Summary – Meeting #5

Community Advisory Group – I-5 Willamette River Bridge Project

May 8, 2007, 10:00 a.m. to 1:00 p.m.

Jamie drew three example diagrams of how piers could be placed in the river:

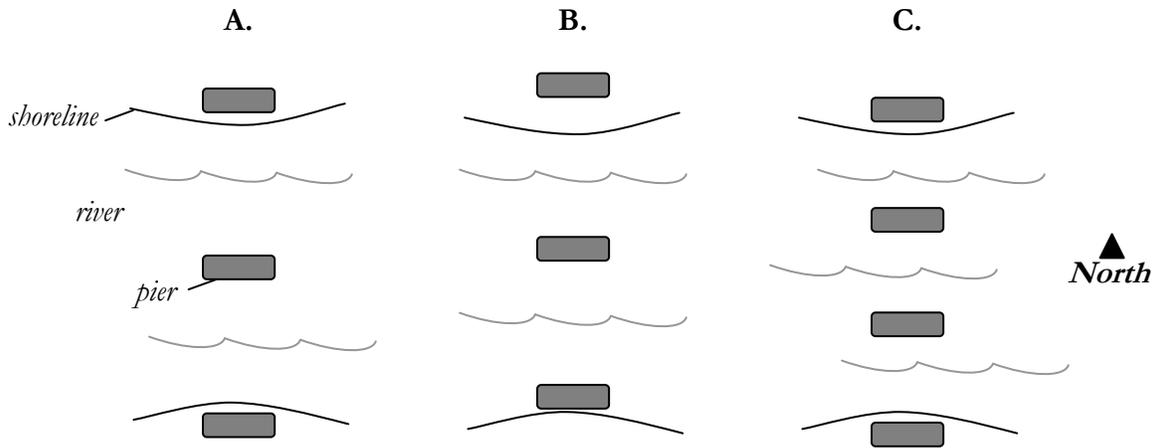
She noted that the CAG needed to determine which models provided generally acceptable locations for each set of piers.

Chris Ramey asked whether it would be possible to shift any of the pier options so as to avoid the riparian zones. Tim noted that example B seemed to offer the most versatility in avoiding the riparian zones.

John Barofsky noted that there appeared to be no way to completely avoid both the riparian zones and the river, and raised the question of how to yield the most minimal impact. He said that he felt that the CAG would prefer unequal spans if it meant reducing impacts to the riparian zones. Lou indicated that it could be possible to engineer around the riparian areas. There was some discussion of what “riparian” means. James noted that it’s not clearly defined and could mean the bank itself or the whole flood plain. Chris suggested placing the piers as far from the water as possible. Pat French suggested defining the riparian zone as more than just the slope of the bank. She said that she preferred that the bike path should pass on the river-side of the piers instead of having a pier between the bike path and the river creating a tunnel effect. She suggested that option C could be eliminated while options A and B could go forward.

Jamie noted the general interest in having longer spans with the piers moved away from riparian areas. She asked whether the group could consider eliminating option C (which would also remove concept #4, the least flexible option,) from consideration. There was consensus from the CAG to eliminate option C.

Chris Ramey noted that if the southern pier in Option B was moved closer to bank, it would eliminate the possibility of creating an arch because of vertical clearance issues. Tim agreed that they would have to evaluate how close they can get to the bank. Chris noted that the CAG needs to decide how it matters where piers will be allowed in the river. He noted that if the piers were to be moved north, onto the small island, then more curve could be possible. Ann requested a simulation to that effect. Charlotte asked about what was on the island. Some CAG members said they didn't know and that it was hard to reach.

- Consider different span lengths. [i.e. not necessarily “equal spans”].
- Piers as far from water as possible.
- [North of the river, Bike] Path on the river side [of the pier], to north.
- Smallest pier footprint.
- Need to continue to consider all criteria.
- This is not a complete recommendation.
- Southern pier moved no further than the island.
